HARTZELL PROPELLER INC.  
**SERVICE BULLETIN**  
TRANSMITTAL SHEET  
HC-SB-61-389

**Pitch Change Knob Brackets/Mounting Hardware**

February 08, 2023

Revision 1 is issued to change the following in the Service Bulletin:

**Safety Wire: 3-blade Propellers**  
**Figure 1**

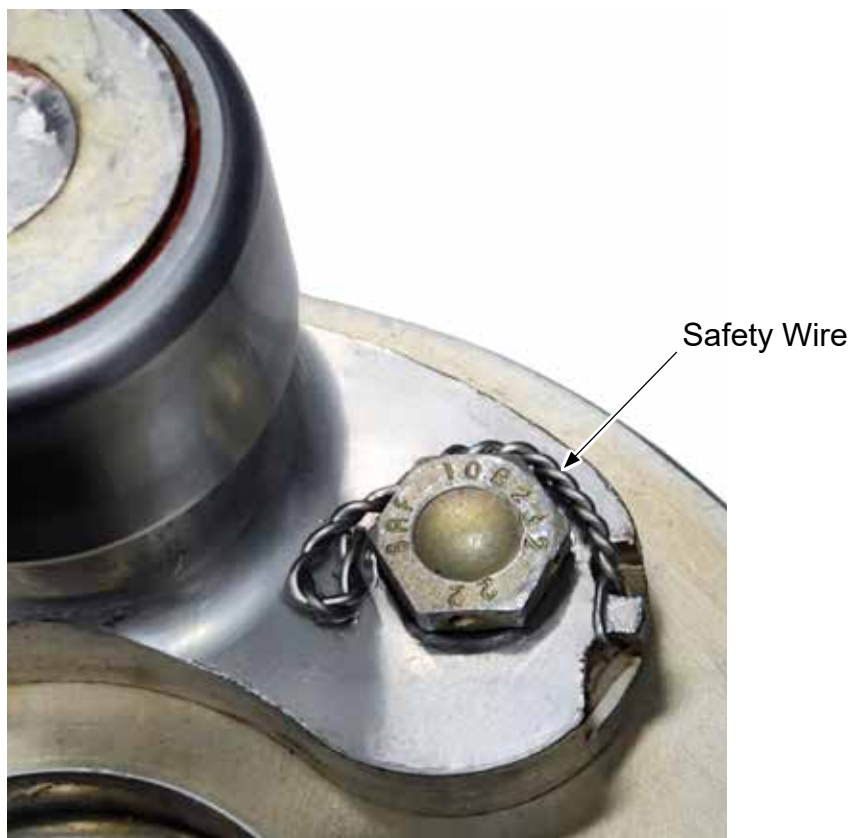
- 3 Attach the 108305-( ) pitch change knob bracket to the butt of the blade with two 108232 hex head bolts.
    - a Torque the 108232 hex head bolts 16-18 Ft.-Lbs. (22-24 N•m).

- 4 Safety wire the 108232 hex head bolts to the hole in the pitch change knob bracket in accordance with NASM33540 and Figure 1.
  - 5 Repeat steps (4)(a)1 thru (4)(a)4 of this procedure for the remaining blades.

**Safety Wire/Silicone Tubing: 4-blade Propellers**  
**Figure 2**

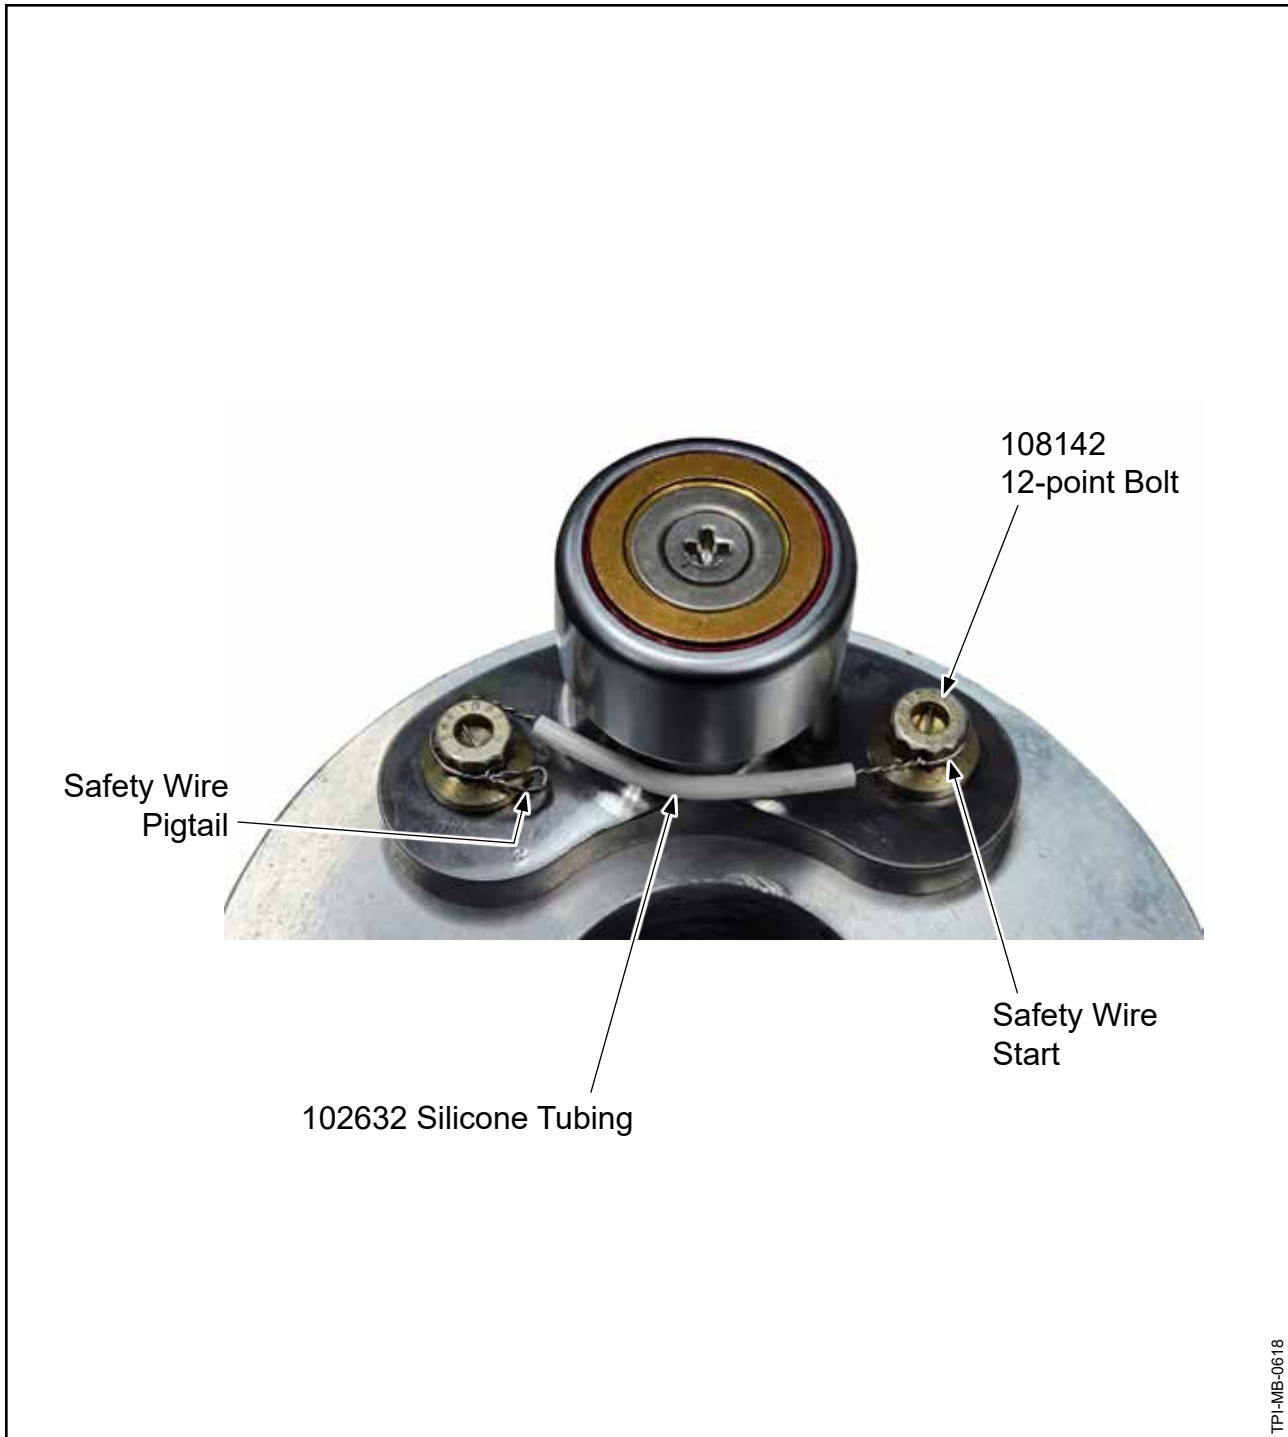
- 3 Attach the 108302-( ) pitch change knob bracket to the butt of the blade with two 108142 12-point bolts.
    - a Torque the 108142 12-point bolts 16-18 Ft.-Lbs. (22-24 N•m).
  - 4 Safety wire the 108142 12-point bolts to each other in accordance with NASM33540 with the 102632 silicone tubing positioned as shown in Figure 2.
  - 5 Repeat steps (4)(b)1 thru (4)(b)4 of this procedure for the remaining blades.
- (5) Complete the assembly of the propeller in accordance with the applicable Hartzell Propeller Inc. overhaul manual.
  - (6) Install the propeller onto the aircraft in accordance with Hartzell Propeller Inc. Propeller Owner's Manual 149 (61-00-49).
  - (7) Make an entry in the propeller logbook indicating replacement of the pitch change knob bracket as terminating action for this Service Bulletin.
